Subdivision and Land Development Cover  
Page for SLD # 13-21

Project Name: 7111 Sheaff Lane Partners, LLC

CONSERVATION SUBDIVISION - OPTION 4  
DEVELOPMENT STUDY EXHIBIT  
7111 SHEAFF LANE  
WHITEMARSH TOWNSHIP - MONTGOMERY COUNTY - PENNSYLVANIA

**Subject:** SLD #13-21 7111 Sheaff Lane Partners, LLC

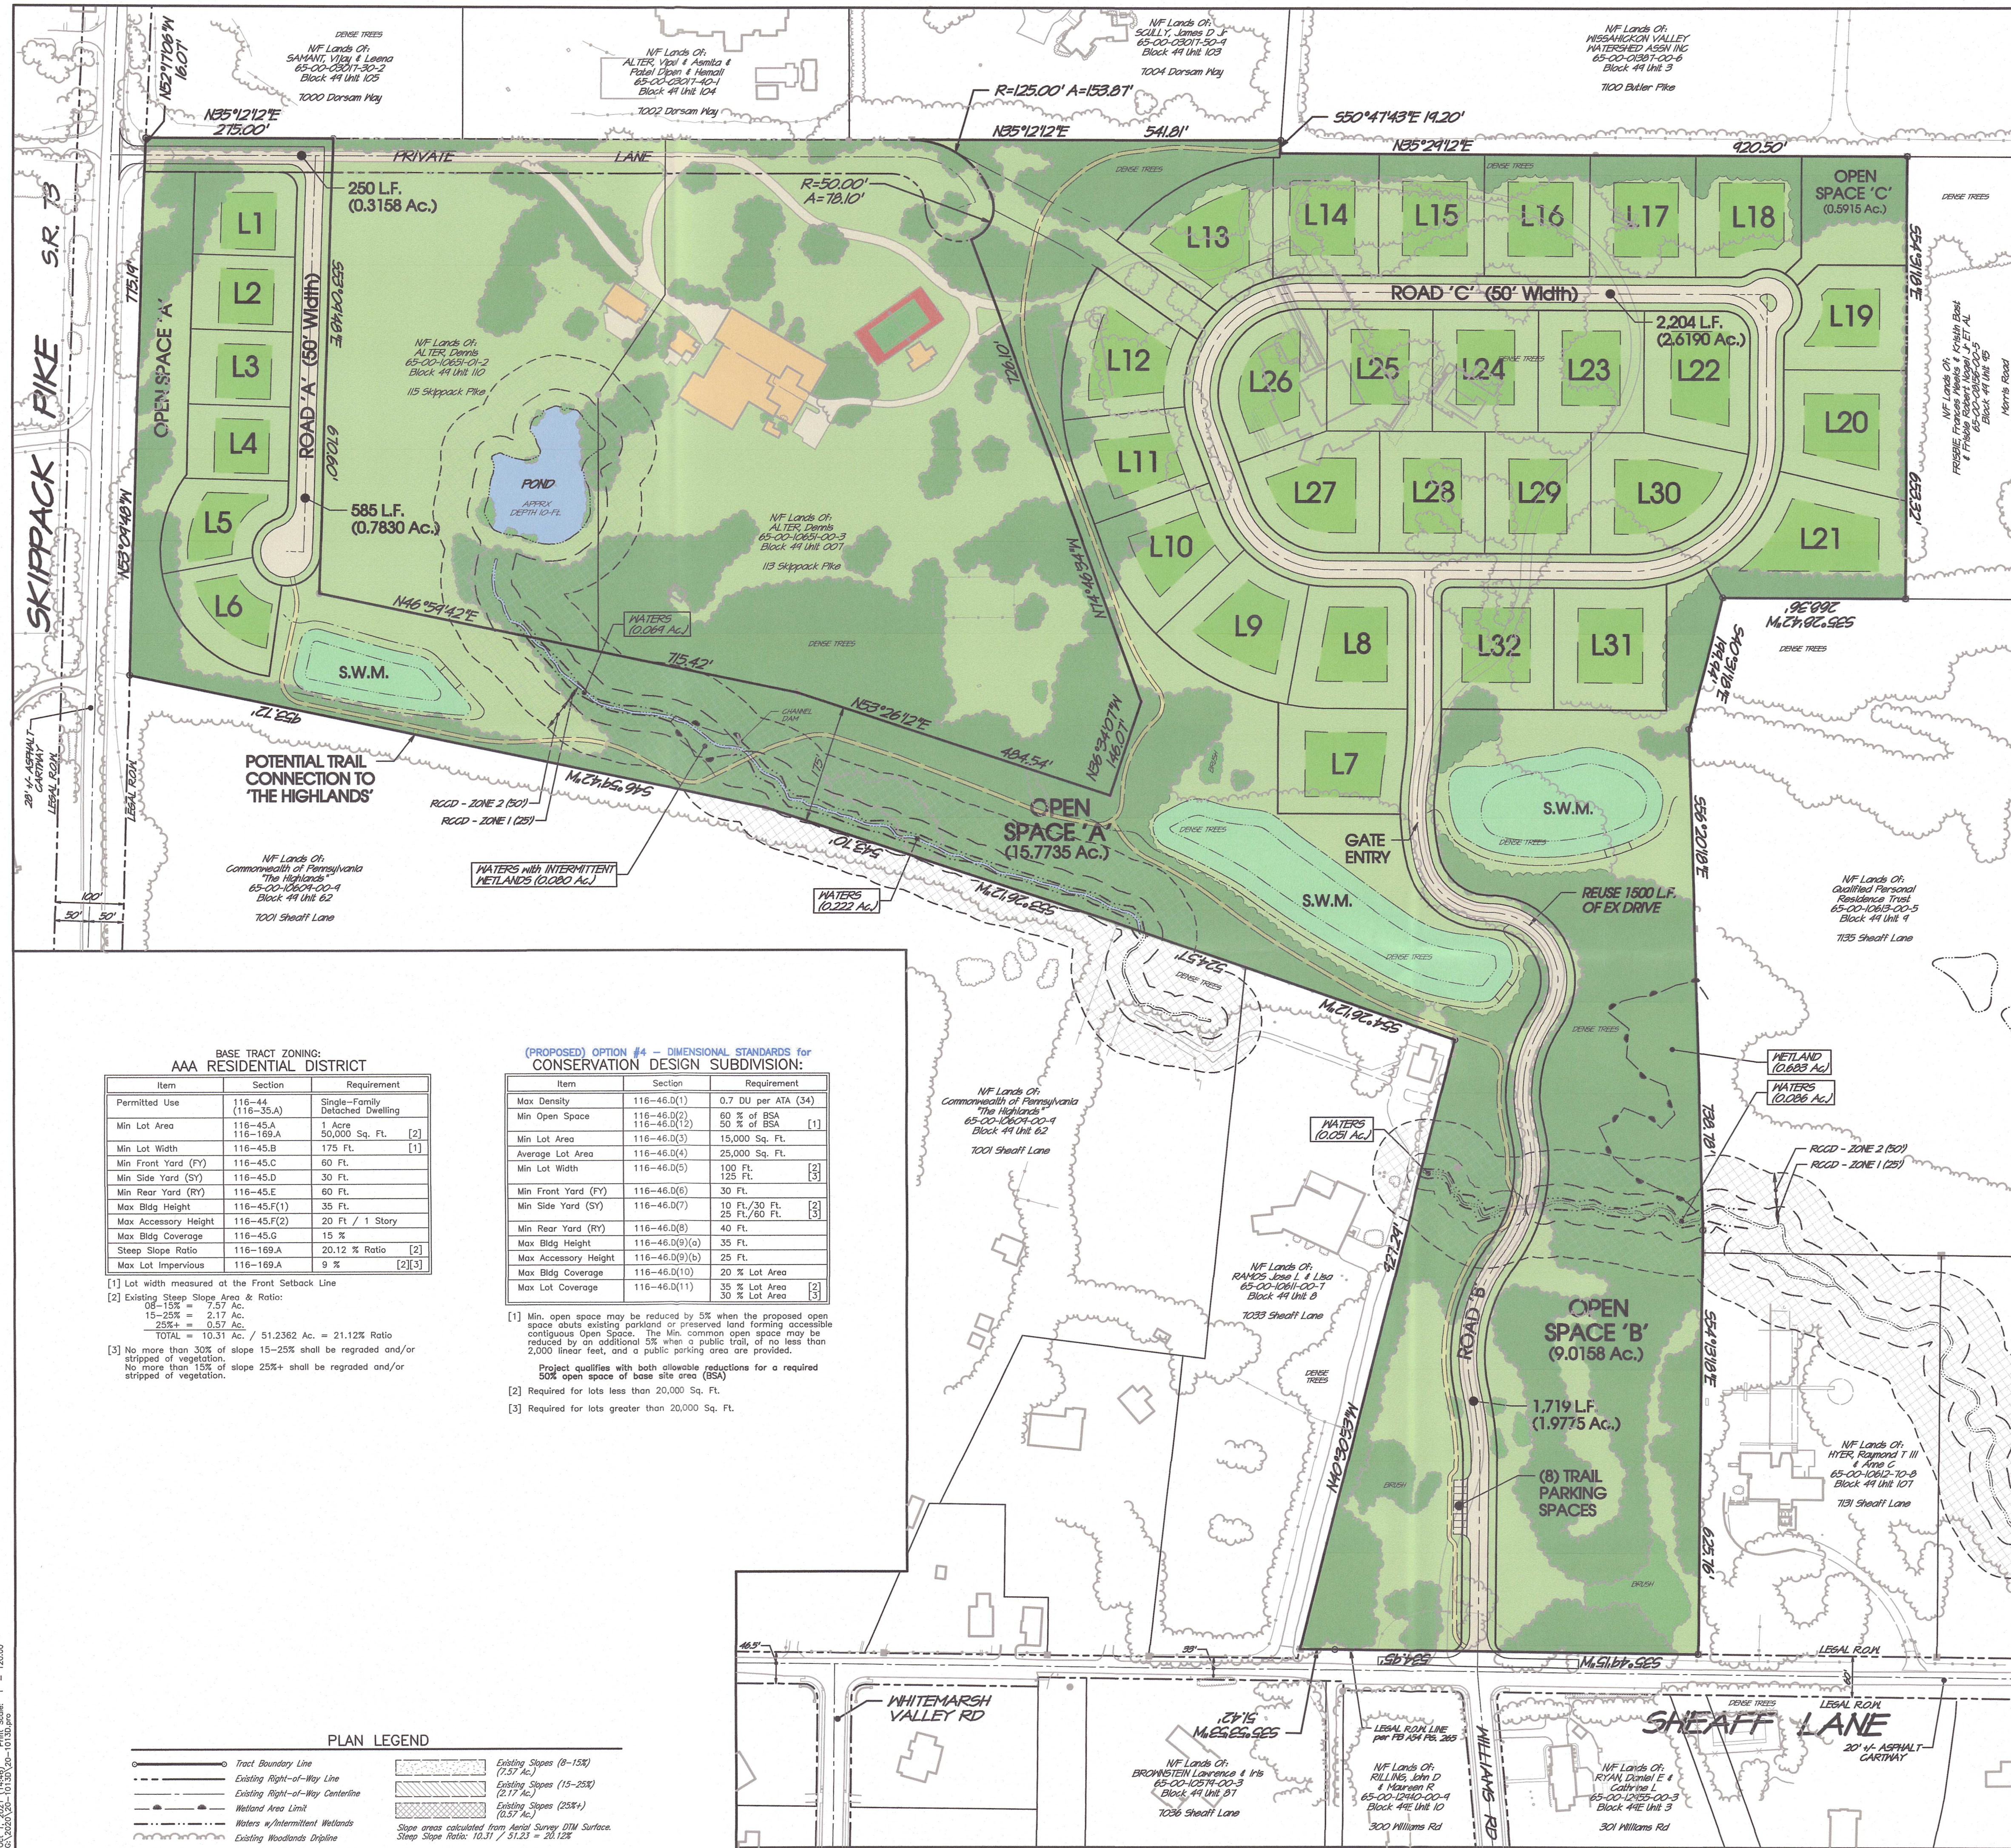
1. Fire Apparatus Access and turning plan not provided. This plan shall meet the requirements as set forth in Chapter 5 of the International Fire Code 2015 edition, Appendix D of the International Fire Code 2015 Edition, and Whitemarsh Township Ordinance #1003.
  - a. Fire Apparatus Access Roads shall be 24' wide with 14' vertical clearance and no closer than 5' to a structure.
  - b. Highest roof surface height shall be provided. This height shall be measured to the eave of a pitched roof, the intersection of the roof to the exterior wall, or the top of parapet walls. If this height exceeds 30ft, the Fire Apparatus Access Road shall be 26' wide.
  - c. Apparatus: Overall length 49' and wheelbase 23' (Tandem axle).
  - d. The security gate shall be approved by the Fire Marshal with an approved means for emergency bypass.

2. All buildings must have a fire hydrant within 400' of the structure by approved route. The applicant must provide a plan showing the distances to the nearest fire hydrants.
  - a. If the building is sprinklered, then the distance is increased to 600'.
